GEORGIA POWER COMPANY
HATCH NUCLEAR PLANT
PROCEDURE

Emergency Sampling Of Primary Coolant
PROCEDURE TITLE

HNP-4825
PROCEDURE NUMBER

WE.
PROCEDURE REVISION REQUEST

FIGURE 1

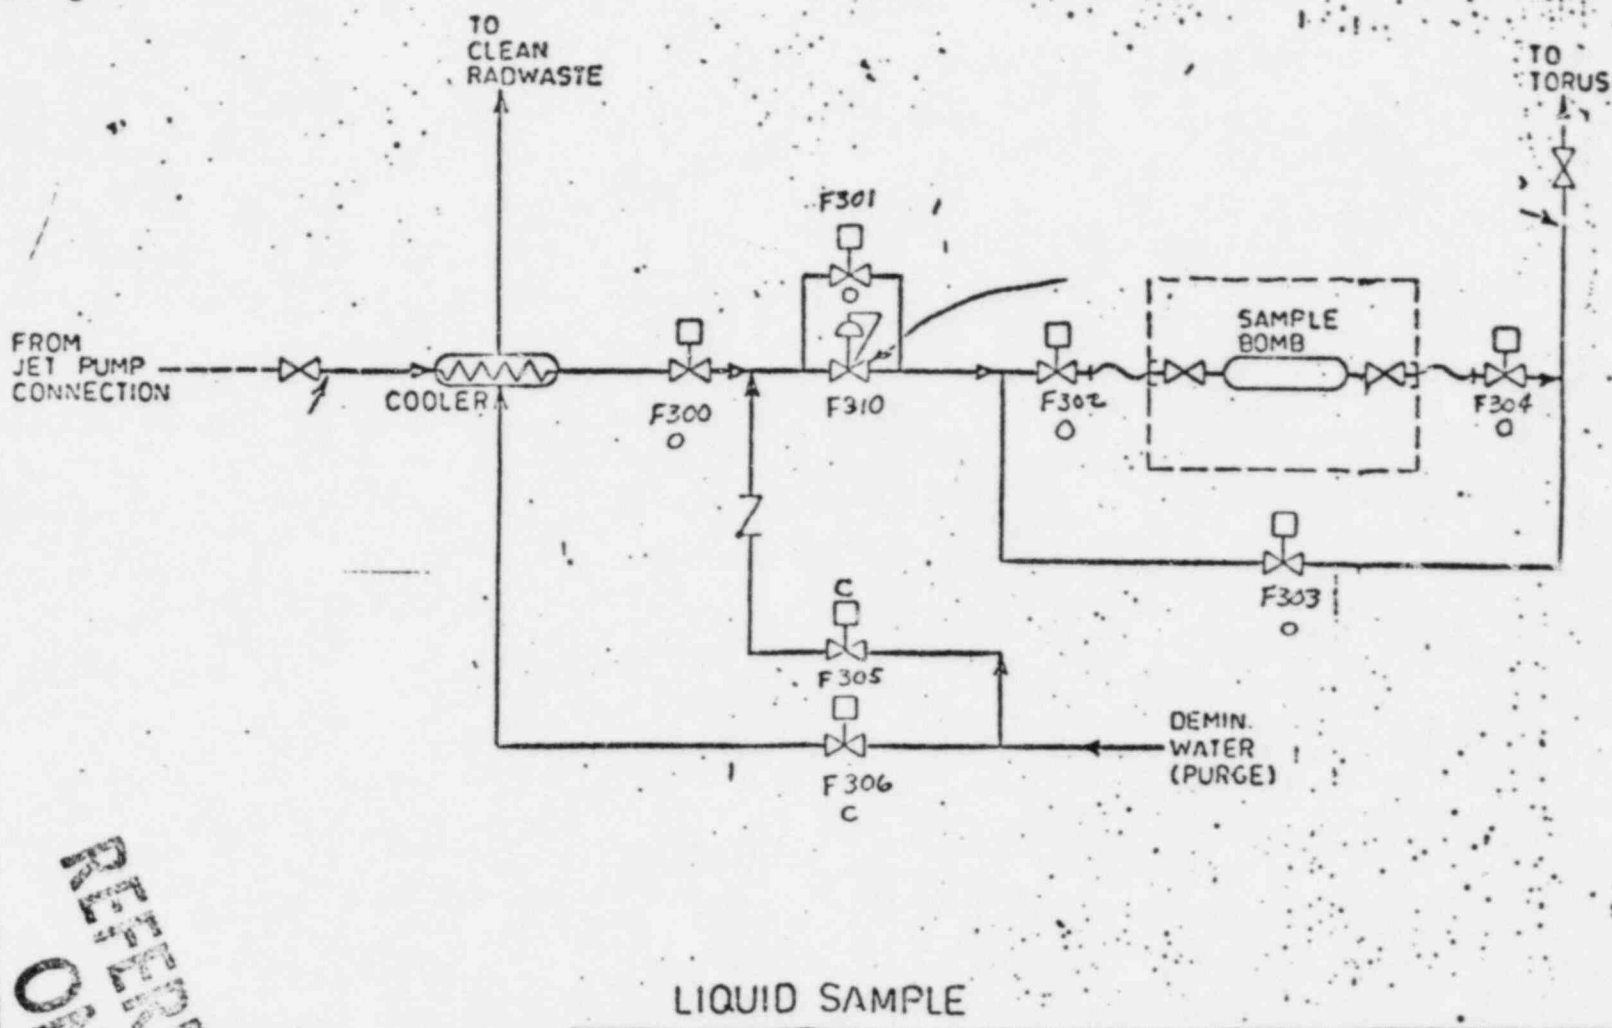
- Paragraph H.3 page 6 of 6. To assure isolation of sample bomb in sampling of Primary Coolant during an emergency.
- Paragraph F. page 3 of 6. To check and make sure control room operated valves are open before proceeding to take emergency sample of primary coolant.
- Paragraph H. page 4 of 6. To assure control room operated valves are open before proceeding to take emergency sample of primary coolant.
- Paragraph F.2.b. - Refer to attached sketch for assistance.
- Paragraph G.2.b. - Refer to attached sketch for assistance.

- a. Open manual valve (1B21 NO33C TVI for Unit 1 or 2B21 NO33C TVI for Unit 2) on jet pump rack. The valves are painted red and are usually in the open position. Must check to make sure the valve is open.
- b. Open valve F306 (chiller water), F300, F301, F302 and F304 on control panel. Flush system for 10 minutes, sample may now be taken. Refer to Figure 1.
